# HISTORIC LANDMARK COMMISSION MAY 21, 2012 NATIONAL REGISTER HISTORIC DISTRICT NRD-2012-0042 Old West Austin 2105 Hartford Road

Demolish existing c. 1959 house and construct a new 2,763 sq. ft. home.

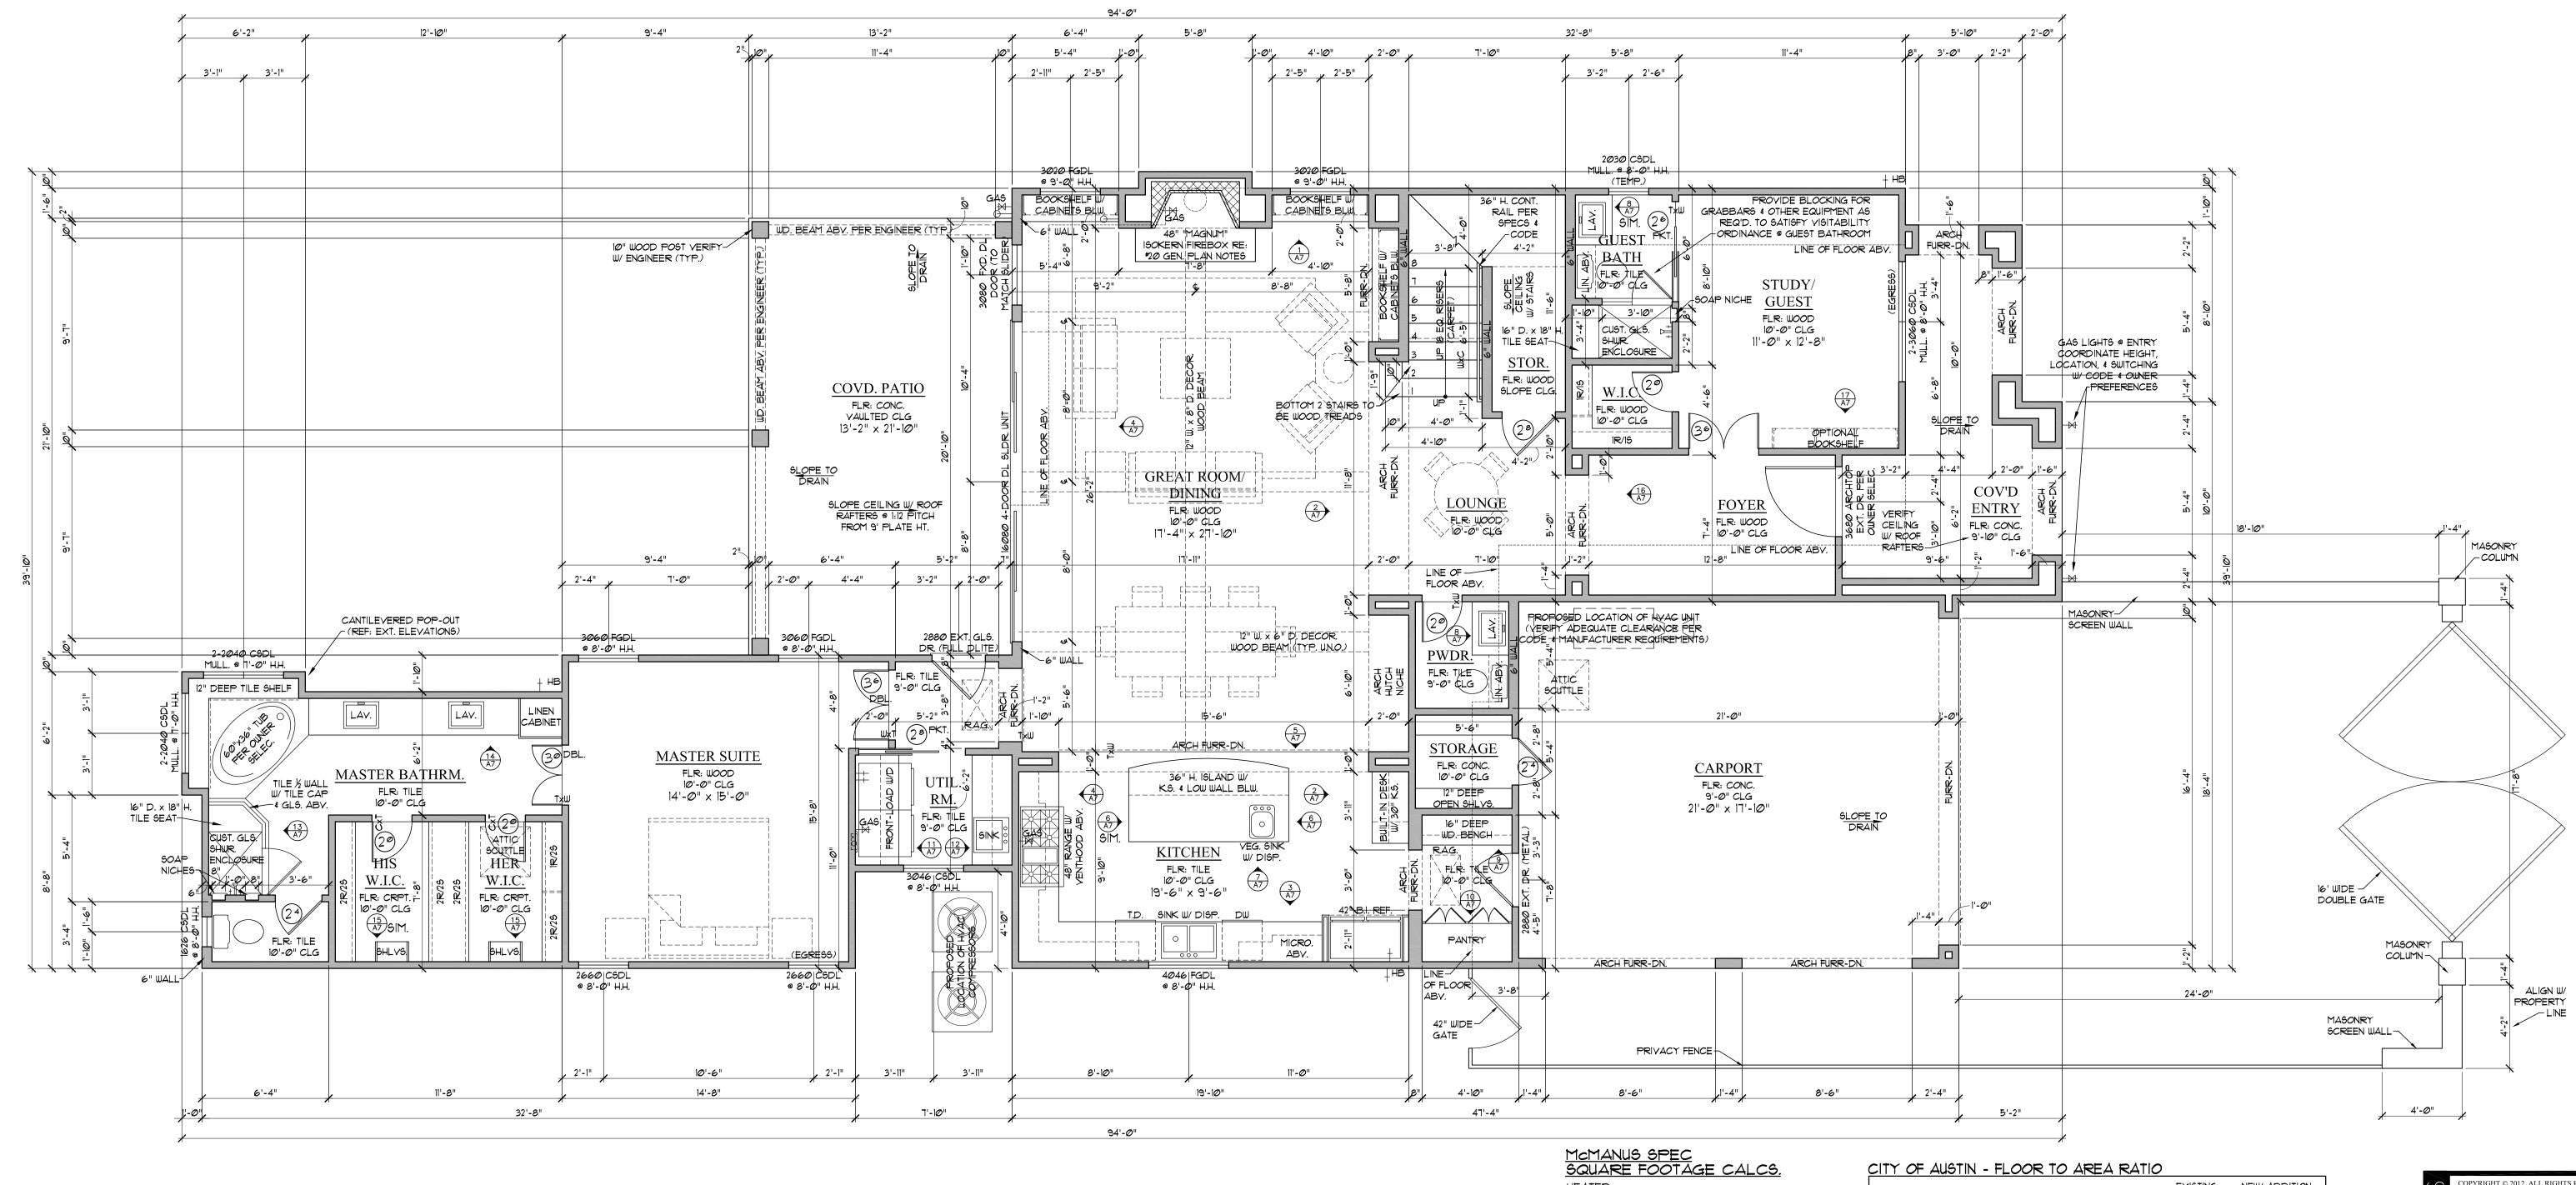
The Tudor design elements reference features found on many houses on Hartford Road, making the house stylistically compatible with the neighborhood. However, the front facing open carport set toward the front of the façade is not typical of the architectural character of the neighborhood, nor is the masonry screen wall and gates.

Release the permit with the following recommendations; 1) set the front of the carport further back from the front façade and add architecturally compatible garage doors, 2) eliminate the masonry screen wall and gates.
